# UNITED STATES PATENT AND TRADEMARK OFFICE

APPLICATION NO.	FILING DATE	FIRST NAMED INVENTOR	ATTORNEY DOCKET NO.	CONFIRMATION NO.
10/590,580	10/23/2006	Richard Fouquer	011460.00037	1073

<b>Office Action Summary</b>	<b>Application No.</b> 10/590,580	<b>Applicant(s)</b> FOUQUER, RICHARD	
	<b>Examiner</b> SARA ADDISU	<b>Art Unit</b> 3722

## **DETAILED ACTION**

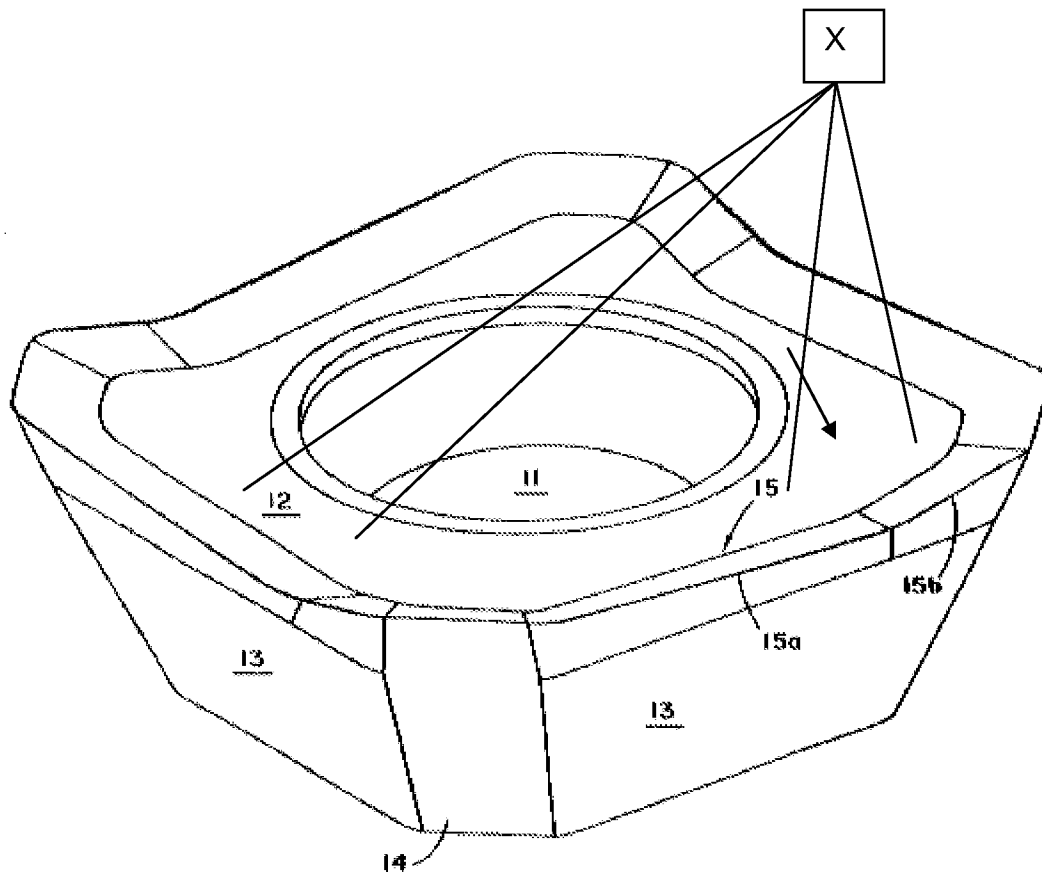
Regarding claims 1, 2 and 10, SATRAN ET AL teaches an indexable cutting insert comprising an anterior layer cutting head portion (i.e. top portion) comprising mutually inclined lateral faces (X: see figure below) of an anterior periphery and delimiting together with a large anterior face (12), a front view profile formed by a certain number of cutting edges (15a, 15b) mutually inclined in the direction (see arrow below) of said profile, and a posterior layer portion (i.e. bottom portion), constituting an anchoring base on a tool holder, comprising planar lateral faces (13) of a posterior periphery, at least some of which are framing supporting faces on walls of a seat of the tool holder (16), characterized in that the posterior periphery (13) comprises a smaller number of lateral framing supporting faces than the number of cutting edges (i.e. there are four posterior lateral faces (13) while there are eight cutting edges (15a & 15b) ('752, figure 1). Regarding claims 7 and 8, SATRAN ET AL teaches the lateral framing supporting faces of the insert having an overall truncated pyramid shape ('752, figure 1
